# Proposed Development at Chatswood Chase

Independent Hydraulic Review  
Findings  
DA2017/503

**Prepared For:** Vicinity Centres as directed by Sydney North Planning Panel**Project Name:** Independent Hydraulic Review for Chatswood Chase DA (2017/503)**Rhelm Reference:** J1205**Document Location:** C:\Dropbox (Rhelm)\J1200-J1299\J1205 - Chatswood Chase Independent Flood Review\4. Reports\J1205-R01-Independent-Review-Rev3.docx**Client Reference:** N/A*Cover image source : Maya Rowley, North Shore Times, 6 June 2016*

**Figure 4-1. RORB sub catchments and CATG setup (CJ Arms, 2018)**

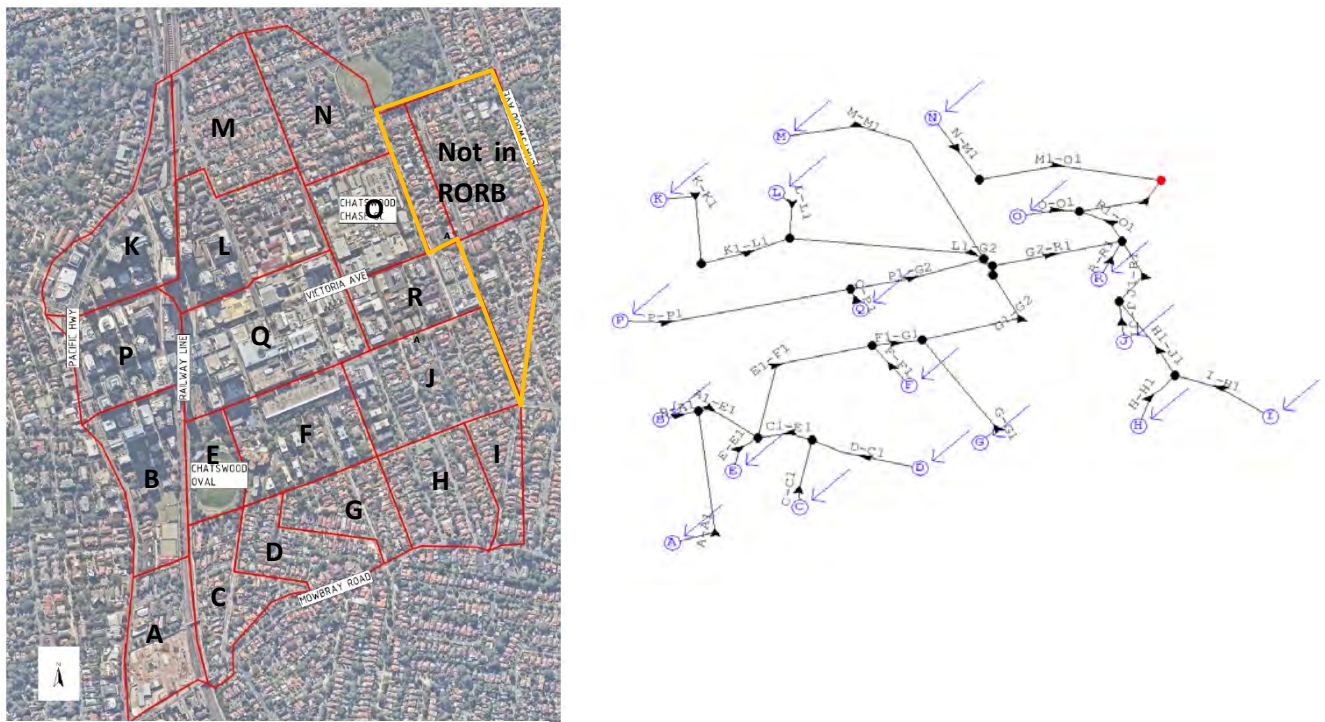
The RORB CATG model was setup using the sub catchment delineation as shown in Figure 4-1. It is noted that the RORB catchment has not been spatially setup using GIS. This makes it more difficult to assess flow path lengths and elevations. However, a manual check of the sub catchments has been completed for area, slope and reach length and these were found to be suitable. The CATG file was setup using lined channel / pipe reaches which is appropriate for this urban setting.

Some of the downstream catchments were not explicitly modelling in RORB (Figure 4-1) and were not included in the modelling. Refer to Section 4.2.1.

Within the *bc\_database* there are three locations assigned as zero hydrographs. These correspond to catchments “Not in RORB” in Figure 4-1. These are all located downstream of the site of interest so are unlikely to influence the basement storage volumes, however they will influence the downstream flood behaviour and the carrying capacity of the 1D network downstream of the site.

Figure 4-2. Difference plot 1% AEP, 2 hour with OSD - RHELM inflows versus CJ Arms inflows

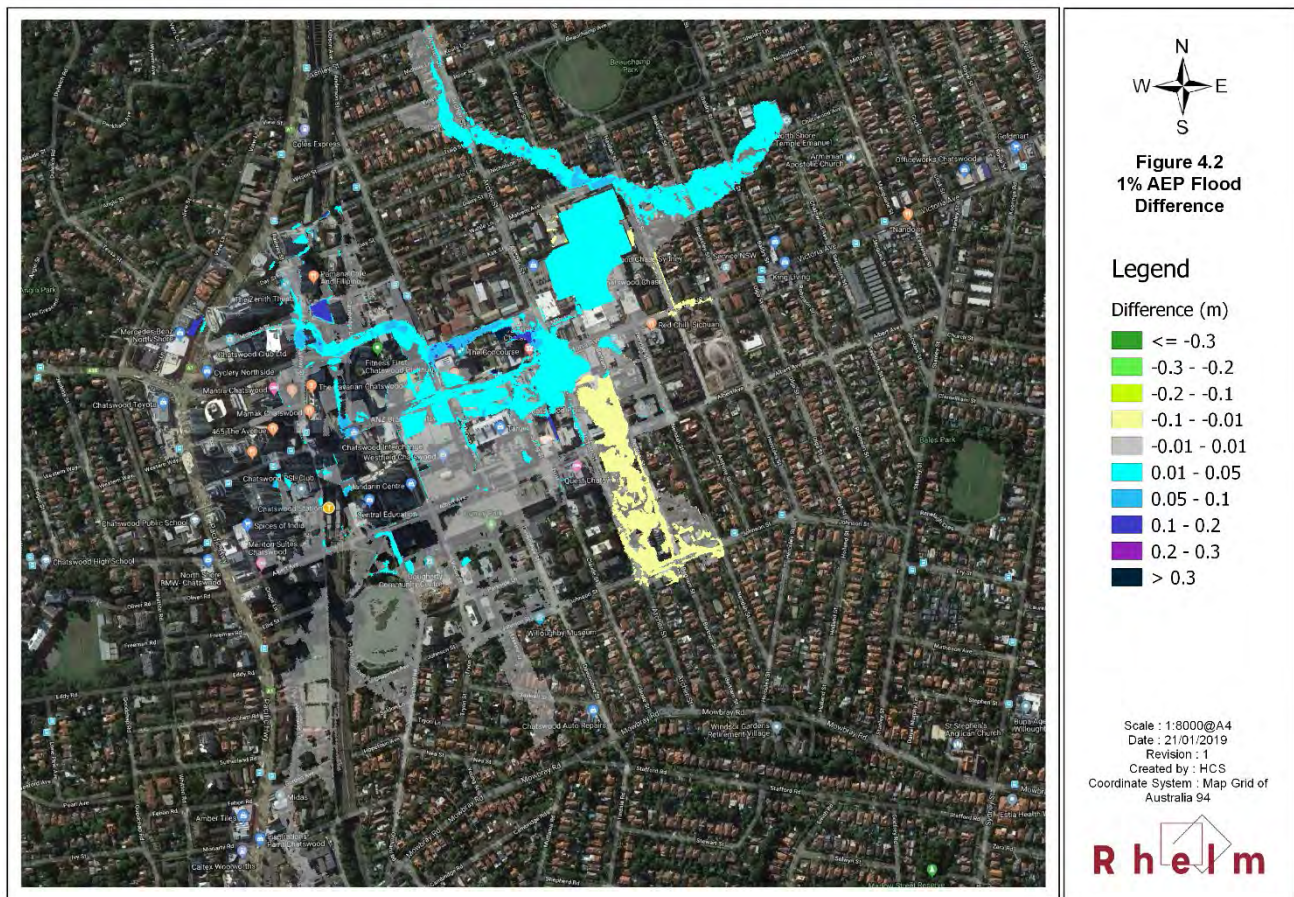
The TUFLOW results were compared using the peak flood levels for the 1% AEP, 2 hour duration with 50% pipe blockage and on site detention added (this was supplied by CJ Arms). The resulting peak level difference is shown in Figure 4-2. The difference is the revised model run (Rhelm) less the results supplied by CJ Arms. Hence a positive difference indicates that the updated run produced higher levels than the original run and negative differences indicate lower levels produced by the update.

For most of the area there was limited change to the inflows hence there were only small changes to the results. Upstream of Ferguson Lane there was an increase in levels of 5 to 12 cm. Similarly, other flow paths have some minor changes. At the Chatswood Chase centre the levels along Victoria Street are not influenced greatly and the car park flood levels increase by approximately 2cm.

Overall, the change in inflow hydrographs did not change the results by a large amount but the flow distribution through the catchment was altered.

**Figure 4-4. Flow path noted through the Westfield Shopping Centre (CJ Arms Model Results)**

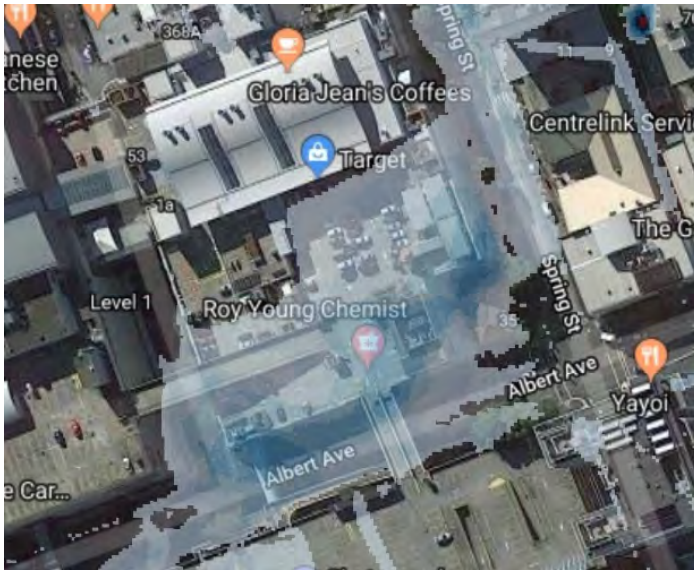
Westfield site – Flows through the Westfield Shopping Centre at Albert Street and Spring Street are unlikely (Figure 4-4). In the Lyall & Associates (2011) modelling this building was blocked from the hydraulic model to force flow around the site. The flow paths would be more likely restricted to the street in this instance and flows would be forced around the building. In the CJ Arms (2018) modelling the buildings were not blocked out, allowing flows to move through the Westfield shopping centre. This may alter the timing of flows arriving at the downstream Chatswood Chase Shopping Centre. But this is likely to be conservative as flows will be arriving sooner than if the building was blocked from the floodplain.

**Figure 4-5. Flows passing through the Regency Tower site at Help Street**

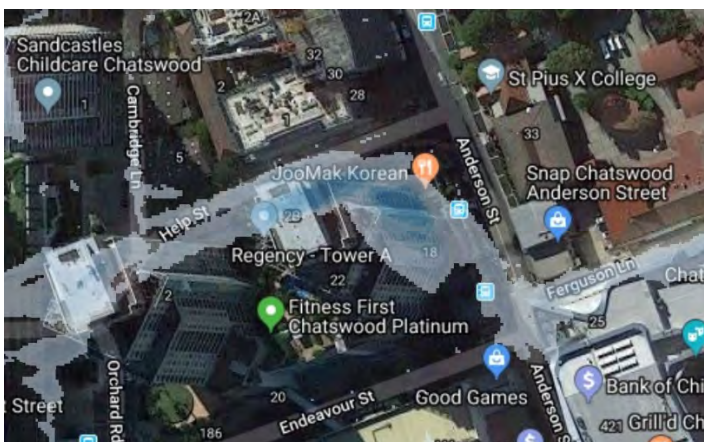
Regency Tower – The flows at this location are more likely to pool at the sag of Help Street before flowing around the corner as shown in Figure 4-5. There is flood protection here to stop flows entering the site. As the building is not blocked in the CJ Arms (2018) model, flows are able to cut through the building reducing the ponding that is likely to occur in this location. As this is upstream of Ferguson Lane this may be worth refining as it will affect the flow timing at the site.

**Figure 4-7. Artificial trapped low point examples**

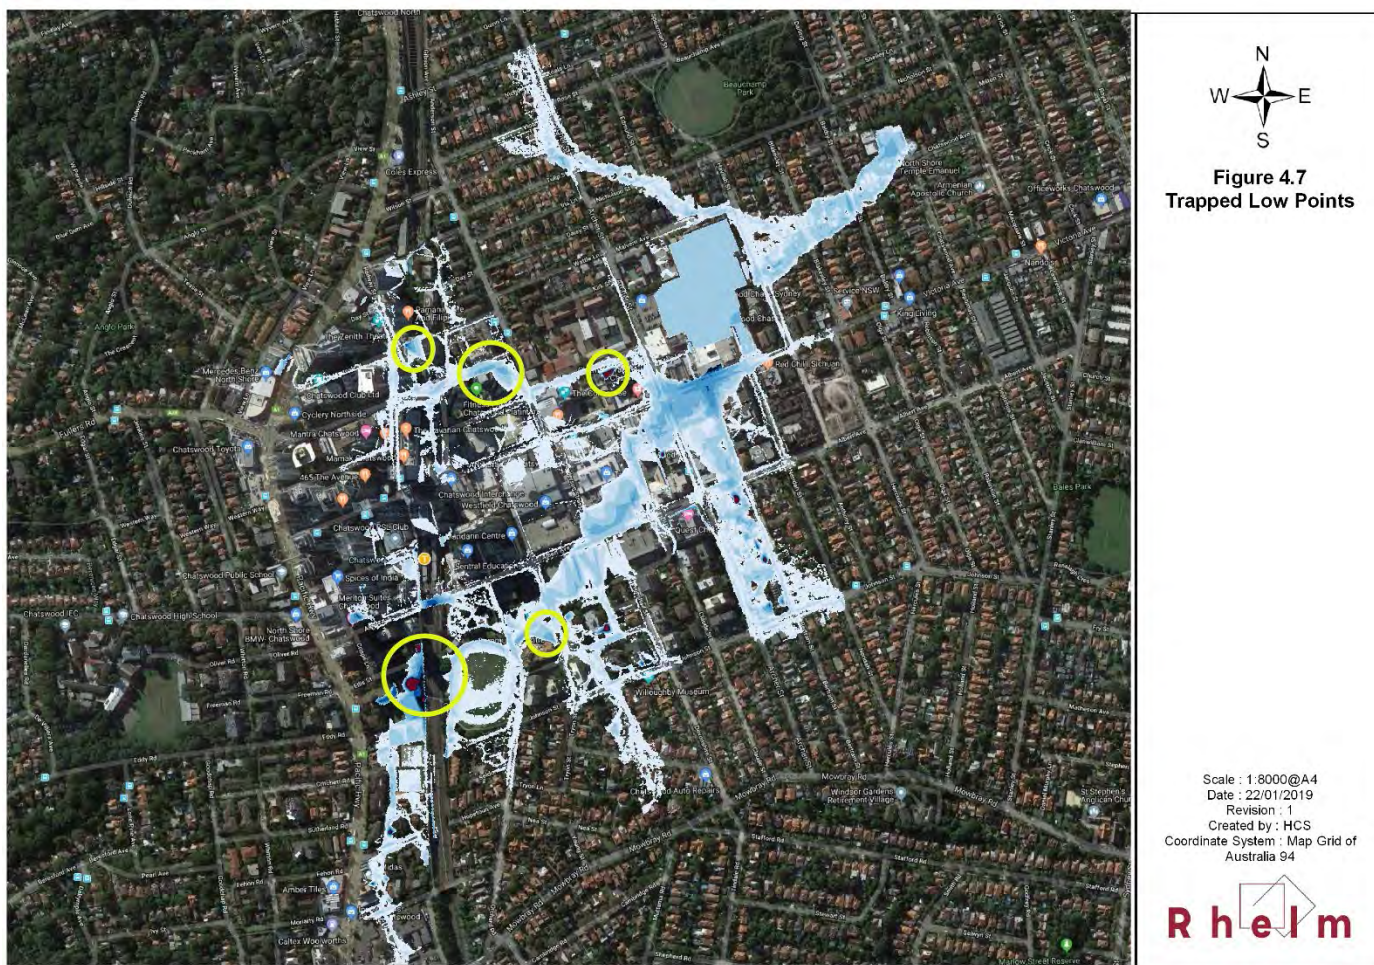
These artificial low points appear to be caused by DEM tin issues. They are not likely to take a significant volume of floodwater from the model, but it is worth noting that these are not actually flood storage areas and could instead have the buildings blocked to remove these issues from the CJ Arms model.

These example locations are shown in Figure 4-7 for reference.

**Figure 4-9. Flow connection to Mills Lane from Victoria Avenue (1% AEP, 2 hour event)**

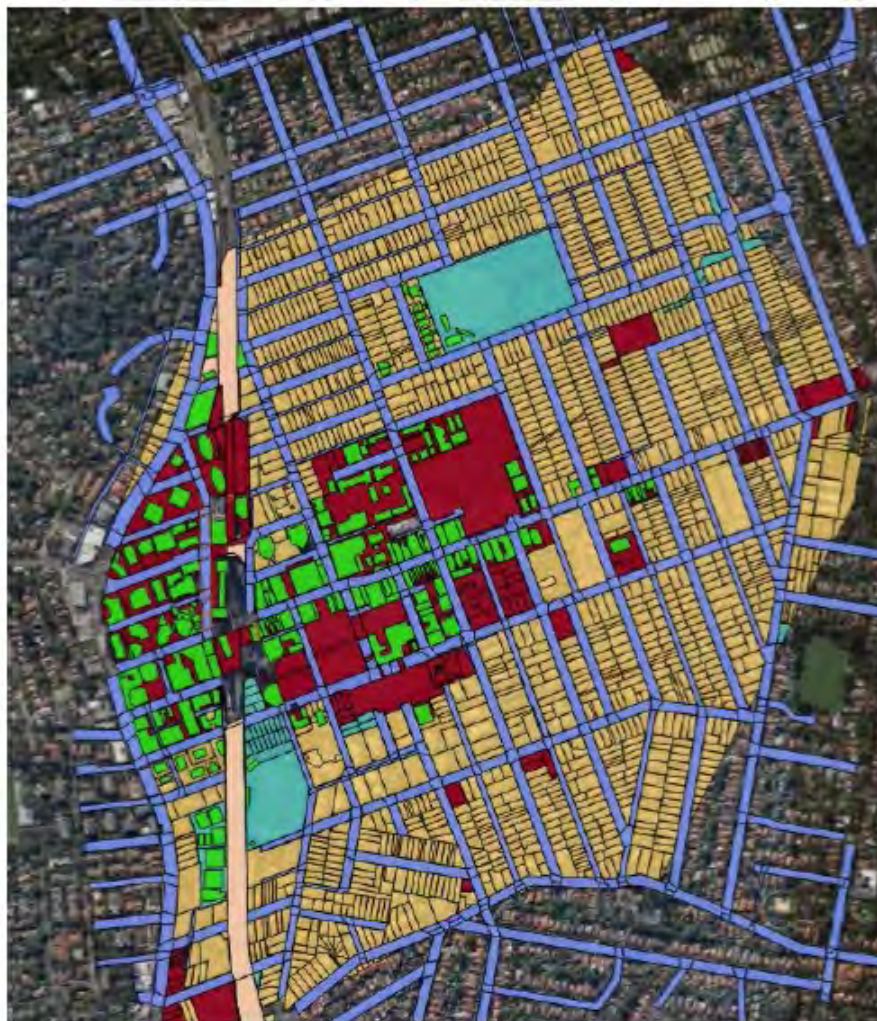
Mills Lane is located upstream of the intersection of Victoria Avenue and Archer Street. It is understood to have some inundation during larger flood events that becomes trapped at a loading dock located in this area. From the hydraulic model results there appears to be a flow path that is active passing from Victoria Avenue to Mills Lane. It is worth establishing if this flow path would be active during inundation events as this appears to be an important source of flooding in Mills Lane, contributing to the ponding in this area. Figure 4-8 and Figure 4-9 shows a view of where this flowpath is, and it is understood to represent an access way through a closed door shown in the photo. From discussions (V Russo, pers comm 14 January 2019), it is understood that there is some access corridor through this location. Given the doorway in this location, it is unclear how much water would actually move between Victoria Avenue and Mills Lane. Depending on the risk to inundation of the loading dock (see Section 6.1.1) this may need to be reviewed.

Figure 6-2. Existing Entry to Mills Lane off Archer Street (Google Maps, 21/1/19)

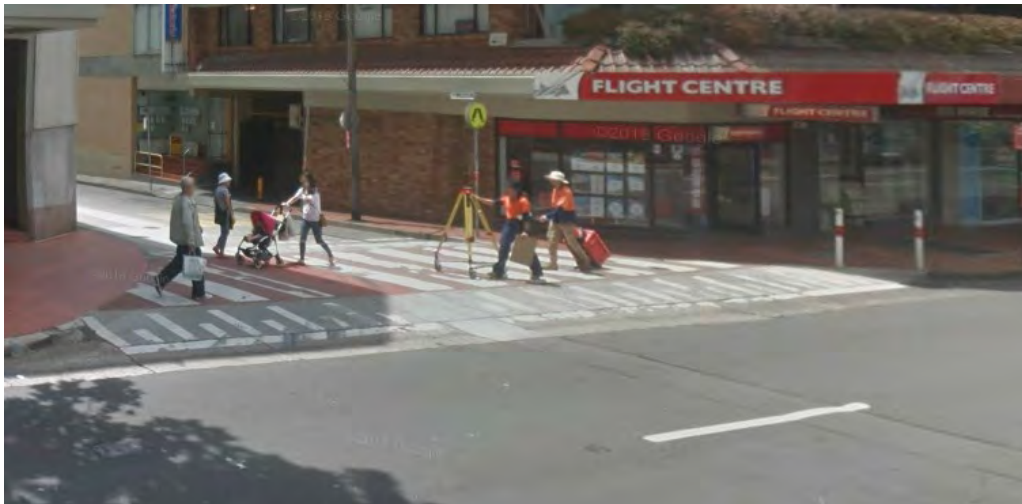
A review of the model results provided by CJ Arms would suggest that the depths entering Mills Lane are very low (only a few centimetres). The existing entry is already raised as shown in Figure 6-2. Consideration should be given for raising the entry to this laneway to mitigate any adverse impacts in this location, as well as potential impacts to stock and other goods that might be stored in this location. The peak flow down Mills Lane is less than  $0.1\text{m}^3/\text{s}$ , and therefore diverting this small flow to the Archer Street/ Victoria Avenue intersection is unlikely to have any material impact.

- Review the potential to raise the entry to Mills Lane to prevent water inflow in this area and protect the loading dock;
- Review the flood planning level for the Lower Ground Floor based on the ponding in this location.
